Appl. No. 10/695,236
Amdt. dated February 9, 2005
Reply to Office action of November 10, 2004

Amendments to the Drawings:

REMARKS/ARGUMENTS

FIG. 1

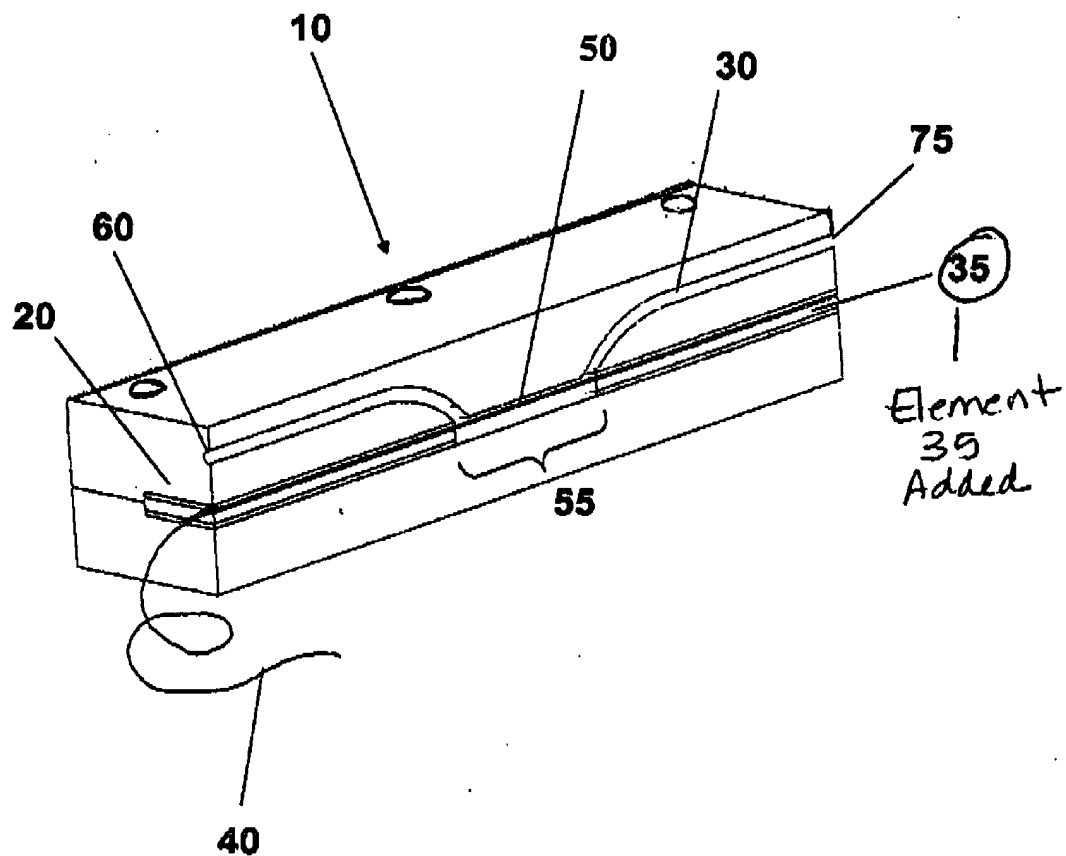
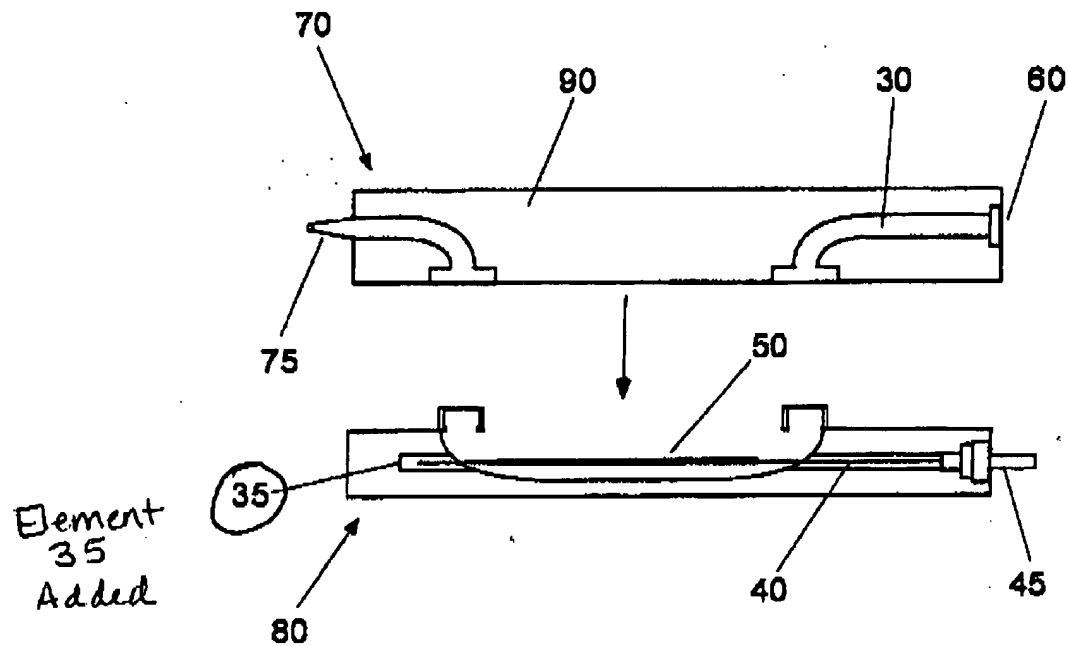
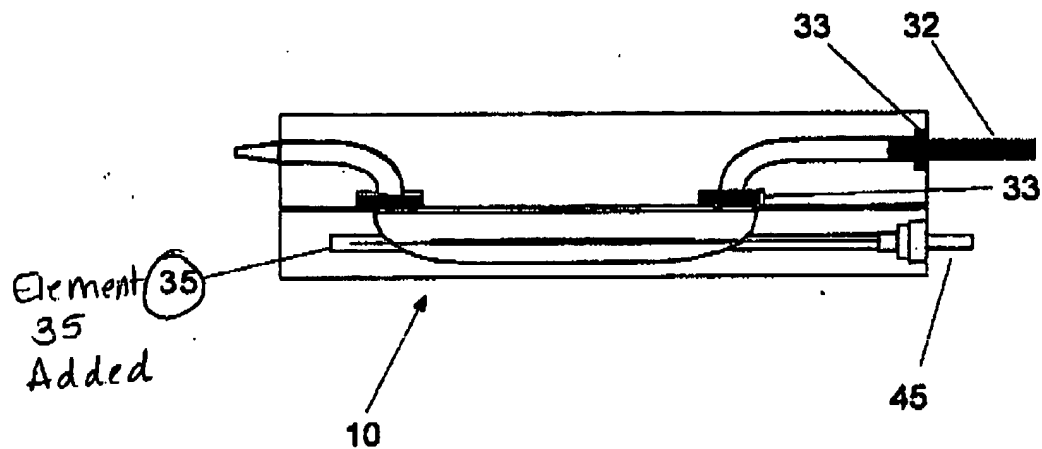
In amended FIG. 1, the previously omitted element 35 has been added. Support for this amendment is found in paragraph [0034].

FIG. 3.

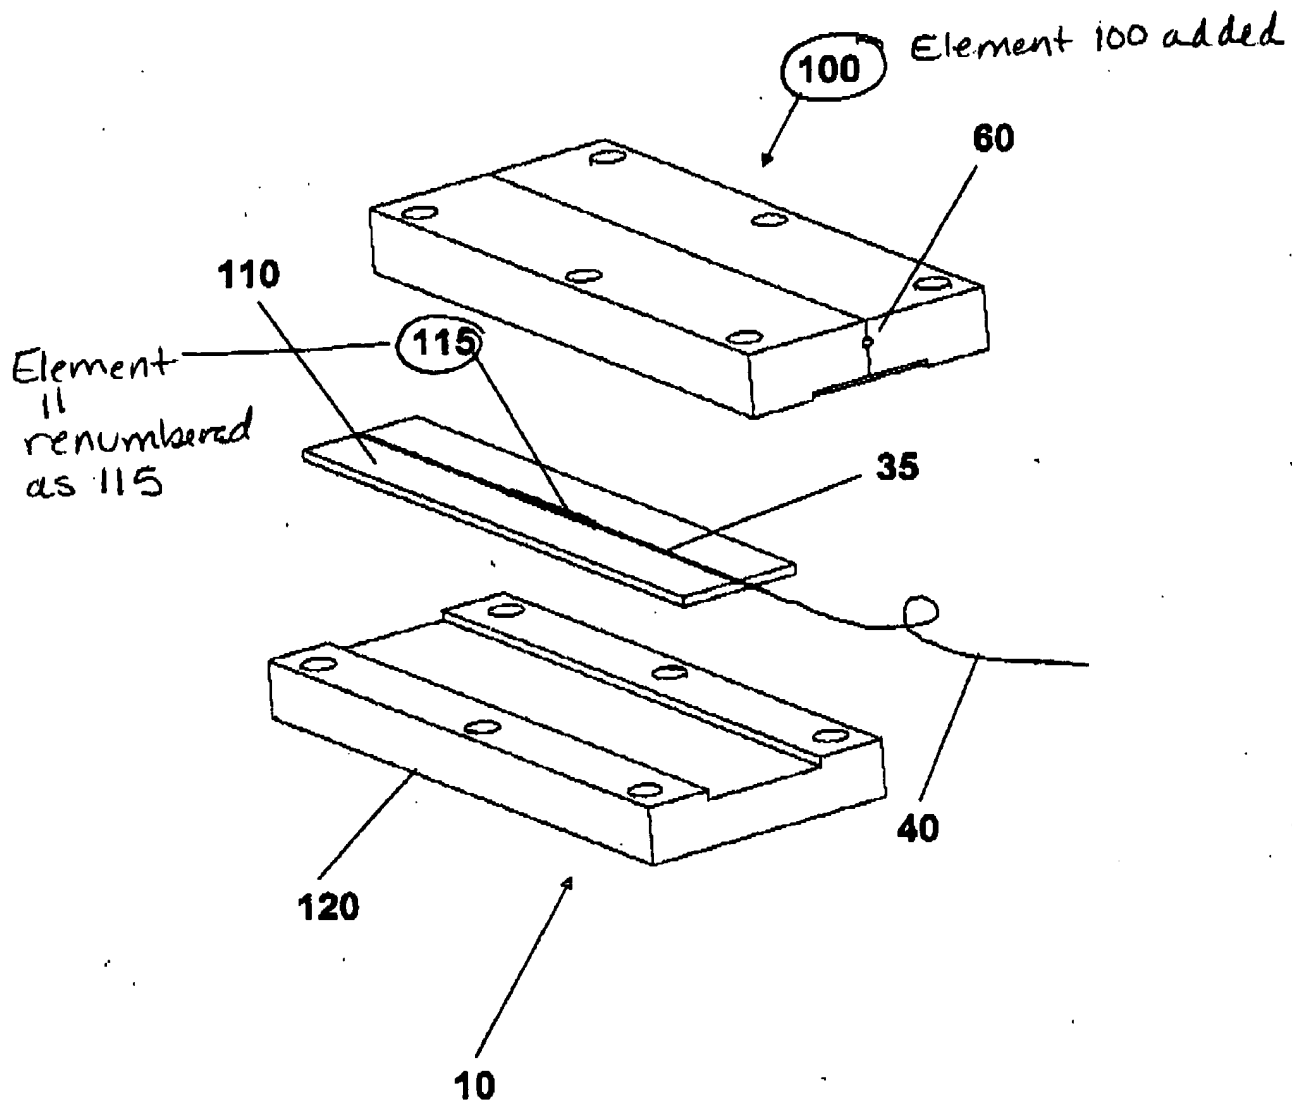
In FIG. 3, previously omitted element 100 has been added. Element 11 has been renumbered as element 115. Support for this amendment is found in paragraph [0040].

FIG. 8.

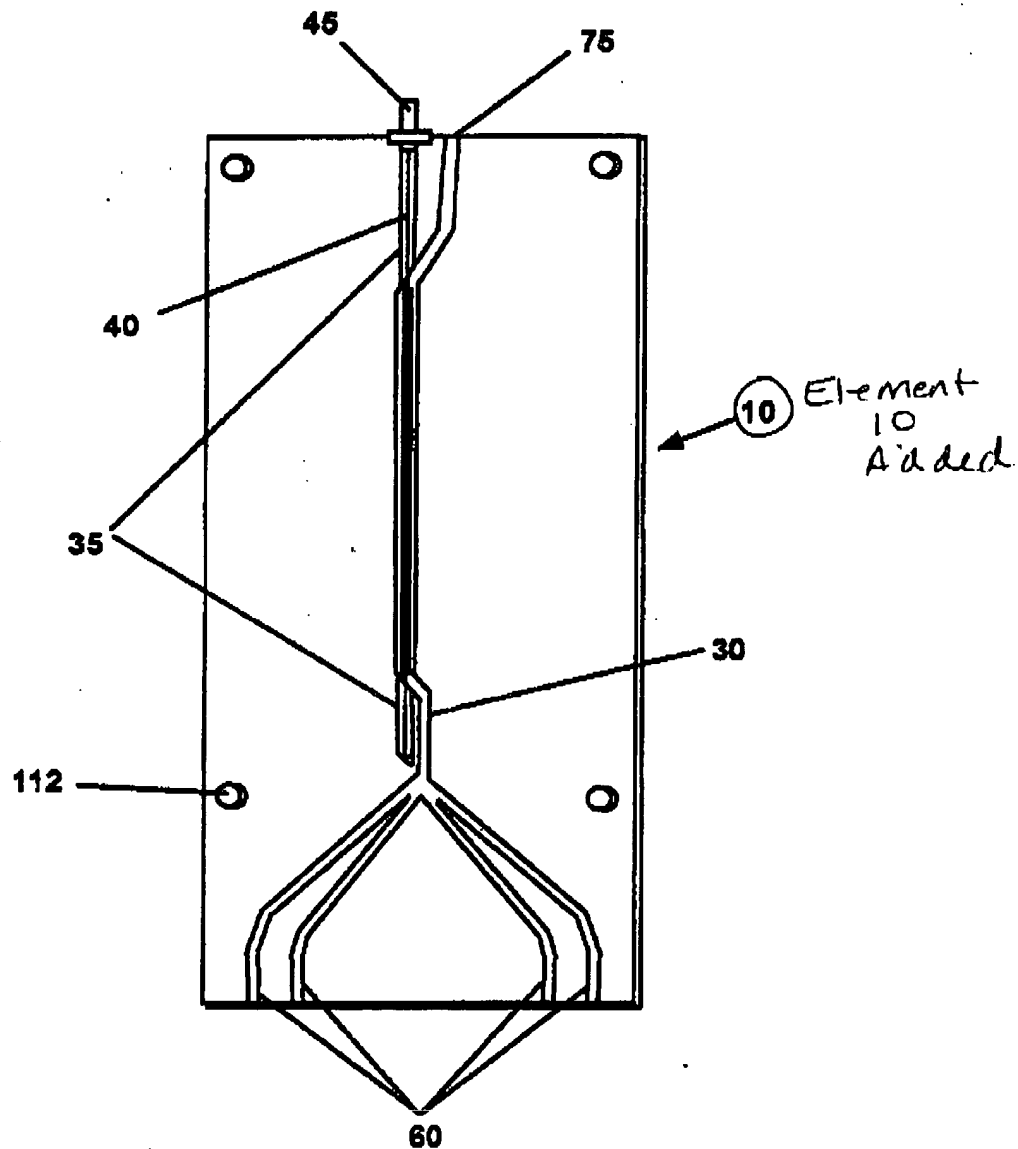
In FIG. 8, previously omitted element 10 has been added. Support for this amendment is found in paragraph [0042].

60
FIG. 9.

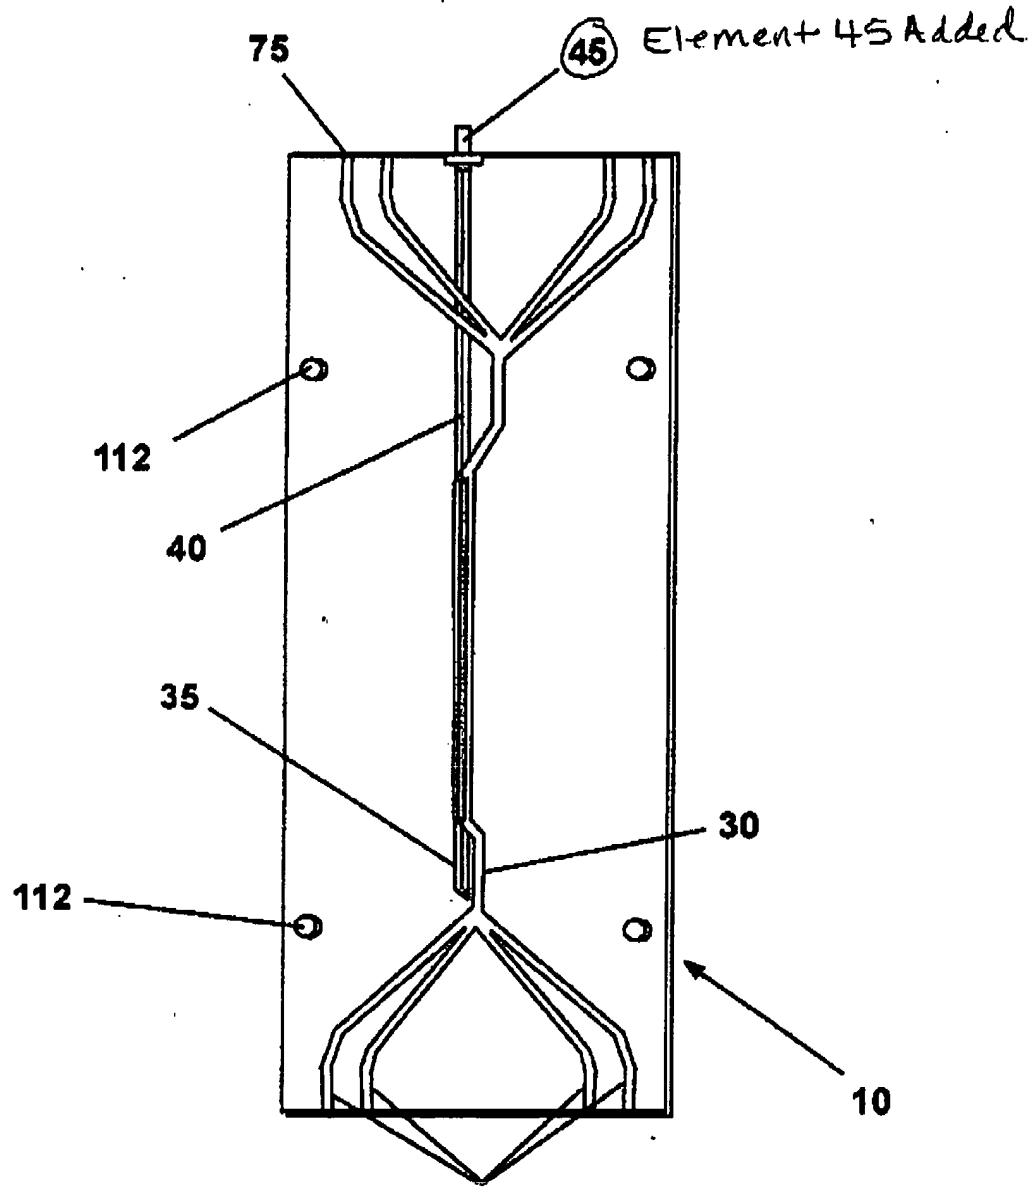
In FIG. 9, previously omitted element 45 has been added. Support for this amendment is found in paragraph [0042].

FIG. 12.

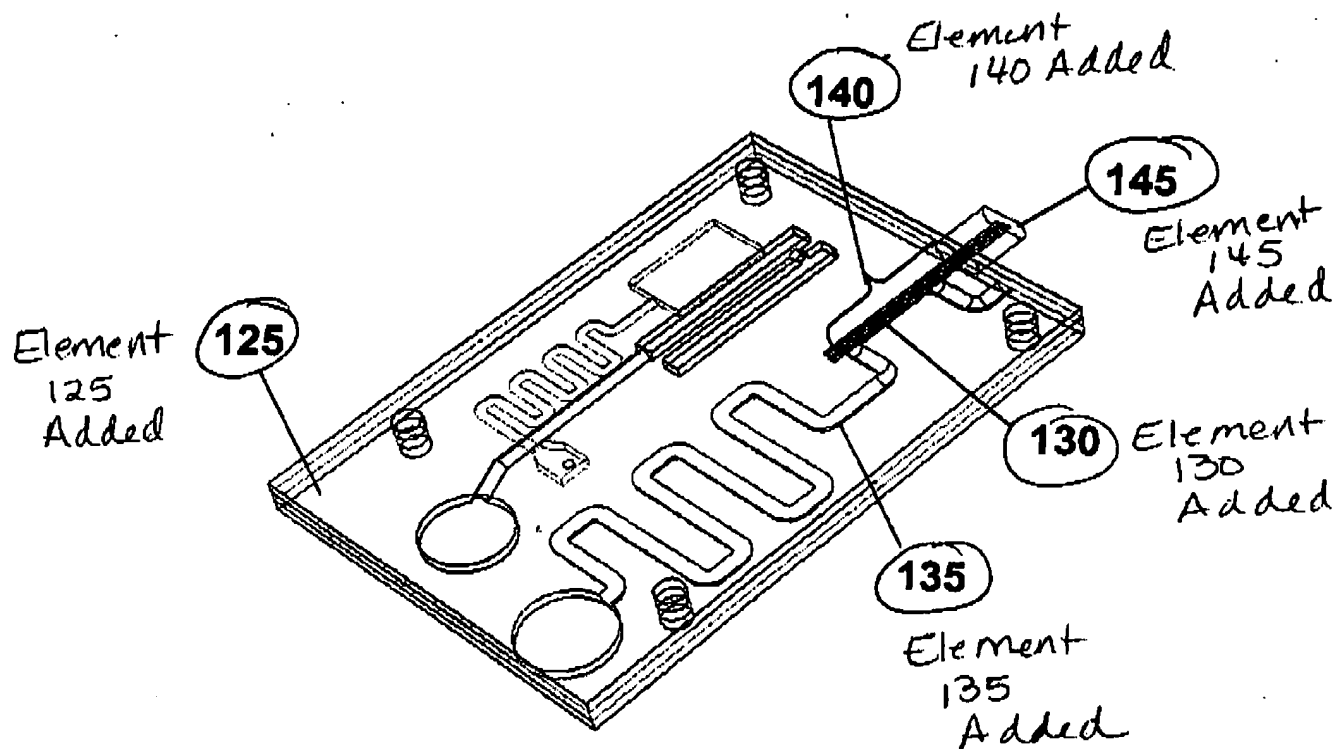
In FIG. 12, previously omitted elements 125, 130, 135, 140 and 145 have been added. Support for this amendment is found in paragraph [0051].
